CDM: Recommendation Form for Small Scale Methodologies (version 01)
(To be used for presenting questions/proposals/amendments to the simplified methodologies for small-scale CDM project activity categories)

<i>Date of SSC WG meeting:</i>	30 January–02 February 2012, SSC WG 35
<i>Title/Subject (give a small title or specify the subject of your submission, maximum 200 characters):</i>	Consideration of monitoring requirement for heat recovery project with an integrated burner
<i>Indicative methodology to which your submission relates (refer the items of Appendix B of the Simplified Modalities and Procedures), if applicable.</i>	AMS-III.Q “Waste Energy Recovery (gas/heat/pressure) project”
<i>Name of the authors of the query:</i>	Cynthia Hendayani Institution: KfW Cynthia.Hendrayani@kfw.de , Helmuth.Horn@kfw.de

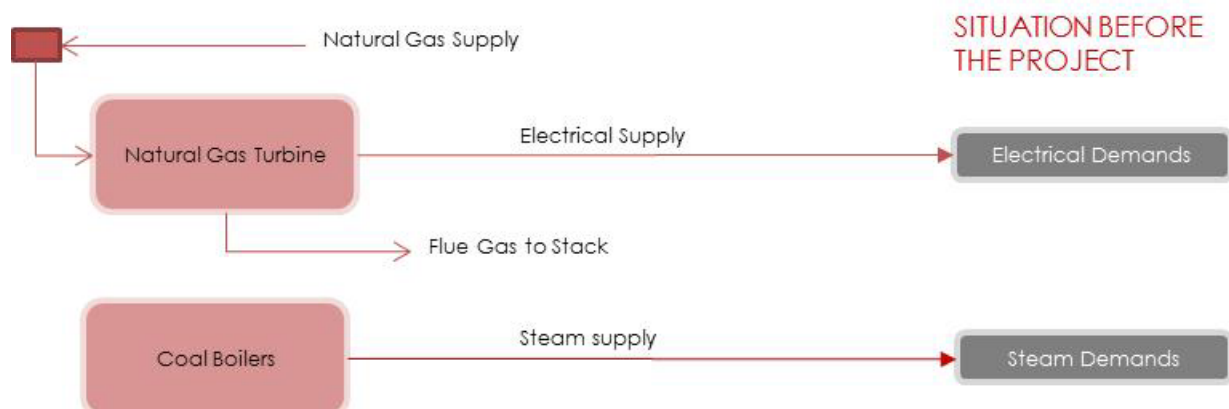
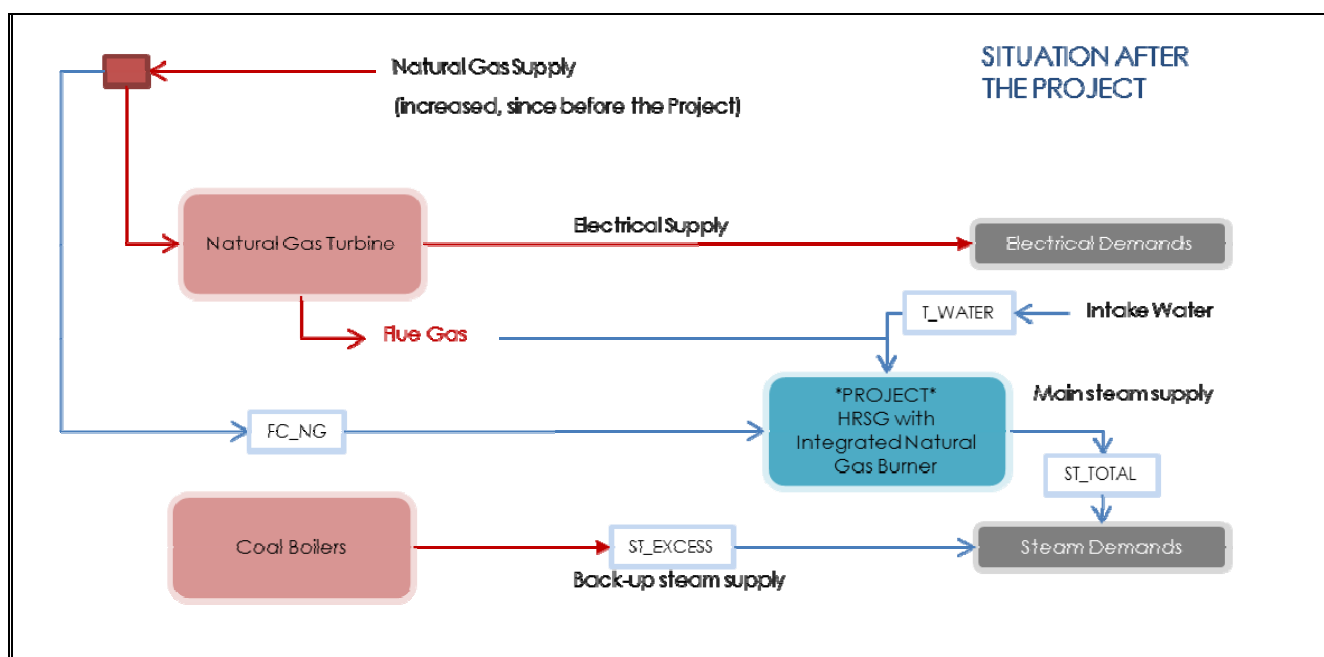
We would like to request clarification by SSC-WG if the above modified equation 9 can be applied to our Project, instead of Equation 7 and 8 of the methodologies.

Whereas the propose modification of Equation 9 assumes a fixed integrated gas burner efficiency throughout the duration of credit period, we do not consider that this propose method to be any less accurate choice compared to equation 7, which assumes a constant heat capacity of the flue gas (C_p), a parameter which, inherently assumes a constant pressure or a constant temperature conditions during it's estimation, and it's magnitude depends on the composition of the flue gas, which ultimately also depends on the properties of natural gas being combusted in the power plant.

If this this method can be applied to our project, we will monitor the following parameter: (a) total steam output (in energy term), (b) the natural gas intake & properties (composition and density), instead of monitoring of waste-heat (WECM) quantity and properties (as stipulated in paragraph 17 (b) and (d))

In order to assist the decision making process, we provide you with the illustration of the situation before and after the Project.

The proposal made in the submission considers the efficiency value provided by the manufacturer of the burner this procedure would result in an overestimation of emission reduction as the burner efficiency will be of higher order (close to 98%) compared to waste heat generation equipment (85 to 88%).

The project proponent may consider applying AMS-III.Q, adopting a value of 1 for fwcm and consider the emissions resulting from the combustion of natural gas as project emissions.

The above will be further clarified in a future revision of AMS-III.Q. For example when the auxiliary fossil fuel is used to supplement the waste energy directly in the waste heat recovery combustion systems, where the energy output cannot be apportioned between fossil fuels and the waste energy, and when the calculation of fwcm is practically not possible due to technical constraints (e.g. waste gas measurement and its quality), then the above suggested procedure could be applied.
